### Planning Commission Meeting Agenda

# Hartland Township Planning Commission Meeting Agenda Memorandum

**Submitted By:** Troy Langer, Planning Director  
**Subject:** Site Plan Application #20-013 Spicer's Orchards  
**Date:** February 18, 2021

Scaled Drawing

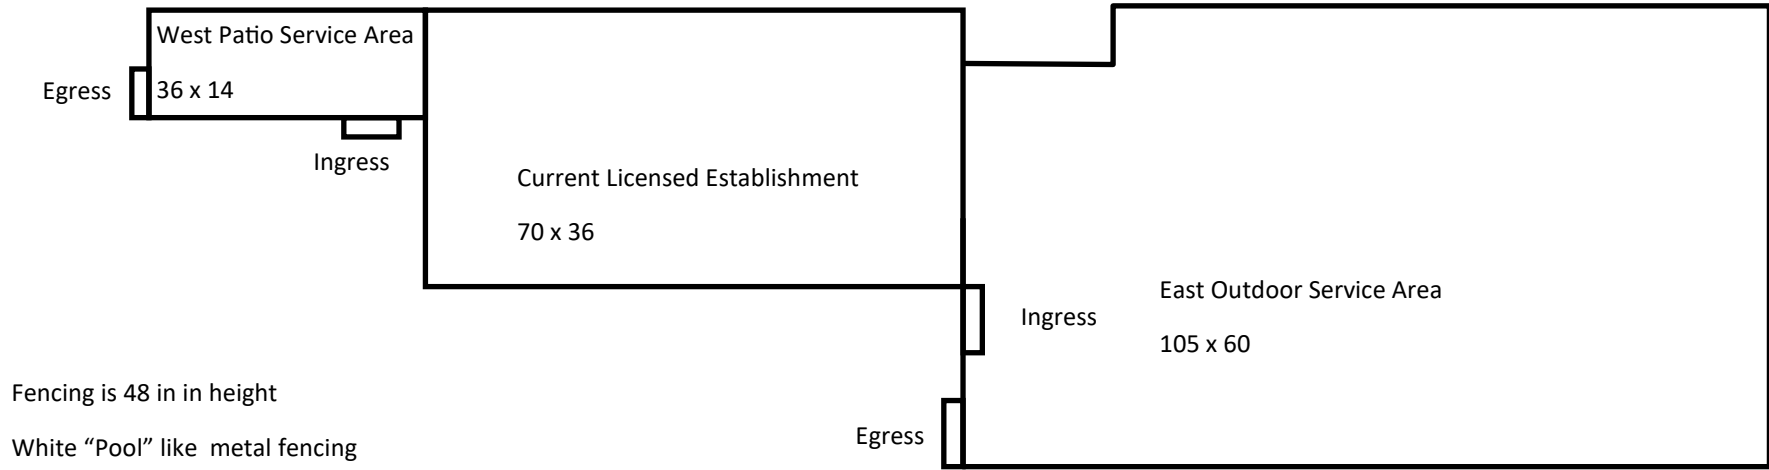
- Please show the fencing around each outdoor dining area. A picture of the style and type of fence with some dimensions would be sufficient.

- Please provide a drawing of the boundary fence around each outdoor seating area, with the fence height stated, and gates shown (“If alcoholic beverages are to be served, outdoor seating and dining areas must be enclosed by a barrier a minimum 3.5 feet above the ground; the barrier must be decorative and cannot restrict visibility; may be constructed of permanent or temporary materials that are compatible with the architectural character of the main establishment; and the barrier must meet all current fire codes, subject to review and approval of the Fire Marshal and must conform to the current Michigan Liquor Control Commission Rules and Regulations”).

We fenced in a small area east of the winery between the parking lot and paved walking path. Due to social distancing requirement there are currently 3 tables 10 feet apart. In the future 6-10 picnic tables can fit in this area depending on the size of the table. The fencing is white metal fencing similar to what you would see around a pool. It currently has a green wind screen to help block a little bit of wind during cold weather. The fence is 48" tall. Wood Chip footing is currently in use.

Fencing is 42 in in height

Wood split rail fencing,
